Planning Application Number: 25/00931/FUL

Highway Reference Number: 2025/0931/04/H/R2

Application Address: Cliffe Hill Farm Little Shaw Lane Markfield Leicestershire LE67 9PP

Description of Application: Re-consultation. Development of a logistics park for storage and distribution (Class B8), general industry (Class B2), ancillary office space (Class E) and associated infrastructure.

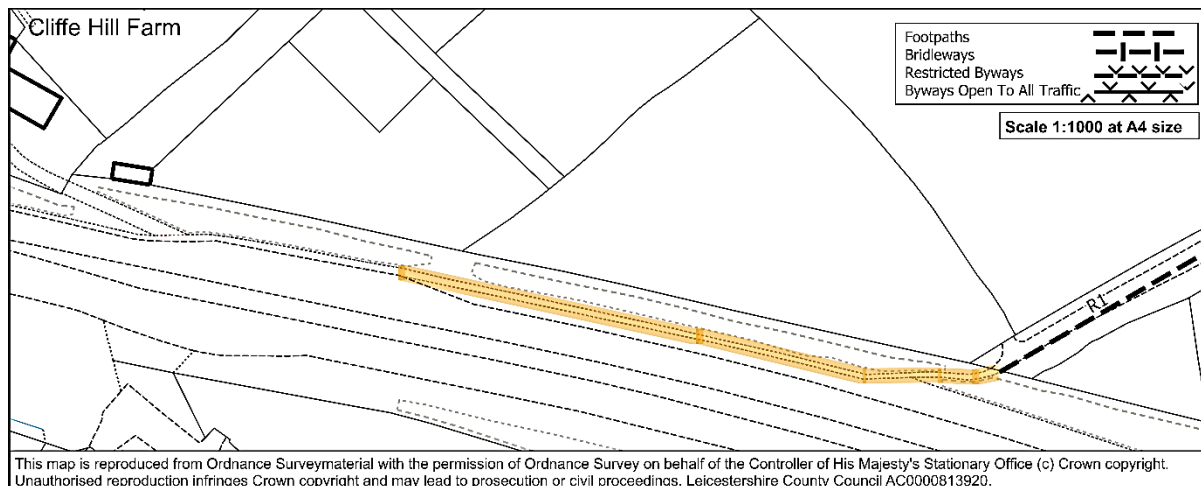
From the south end of Footpath R1 pedestrians go westwards on a grass path along the eastbound A50 verge to reach the footway of the nearby bus layby; adjacent to this there was a tarmac path over the dual carriageway central reservation for access to Altar Stones Lane towards Markfield. This grass verge path is shown on Ordnance Survey MasterMap plans by a parallel thin dashed lines, as highlighted yellow on the map excerpt here:

The currently submitted plans ignore the verge path which is cut-through by the proposed vehicular site entry road, the slip road for which will supplant the existing bus layby. Where the footway and verge path are removed, they need replacing including by dropped kerbs at the site entry road. Details should therefore be provided in respect of this section of the PRoW route. In line with the NPPF paragraph 105 requirement to enhance rights of way the rest of the route to link with PRoW R1 should have a tarmac surface. The public footpath will need to be upgraded to meet design and construction standards set out in the LHDG. For these works to be adequately monitored and delivered in accordance with these criteria the works to the highway (the public footpath) will likely need to be included in a Section 38/278 Agreement. A replacement fingerpost sign matching LHDG drawing SD/FP/7 should also be provided at that point.
